Keystone RV Company SAFETY ADVISORY # 21-214

Winntec Propane Regulators

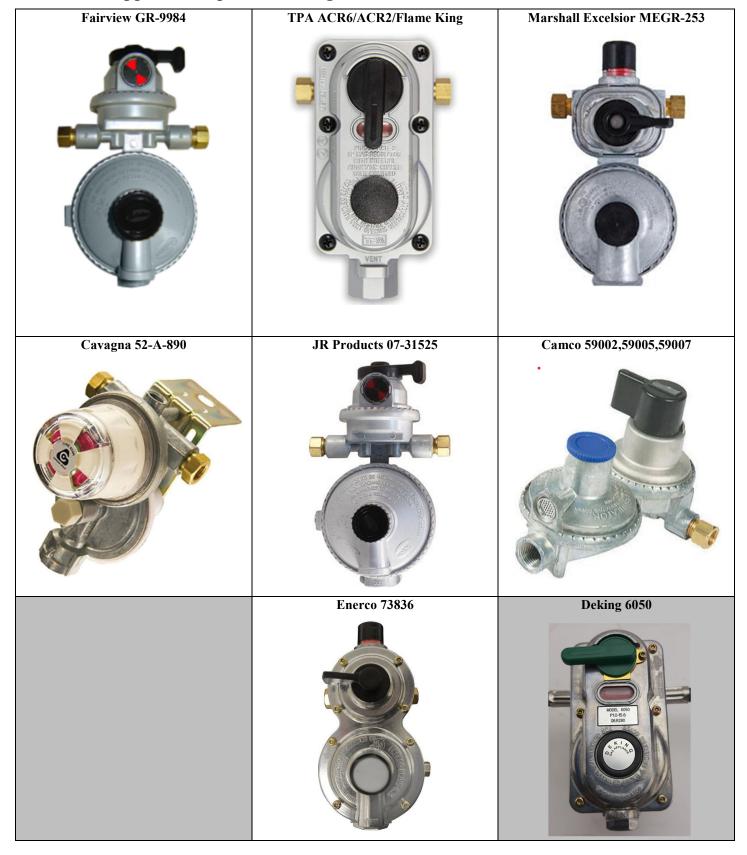
PLEASE NOTE: Regulator date code is required for the claim. See Figure 1.

The remedy is to inspect the date code, see Figure 1. If the date code is 18 XX, 19 XX, 20 XX, or 21 XX replace the existing Winntec propane regulator with a new regulator, the regulator <u>date code is required for the claim</u>. See Figure 1.

Locate the Winntec propane regulator at the LP bottles. Inspect the date code. Only replace Winntec model 6020 with a date code of 18 xx, 19 xx, 20 xx or 21xx.

Remove and replace the propane regulator using industry standards, followed by a drop pressure test to check for leaks.
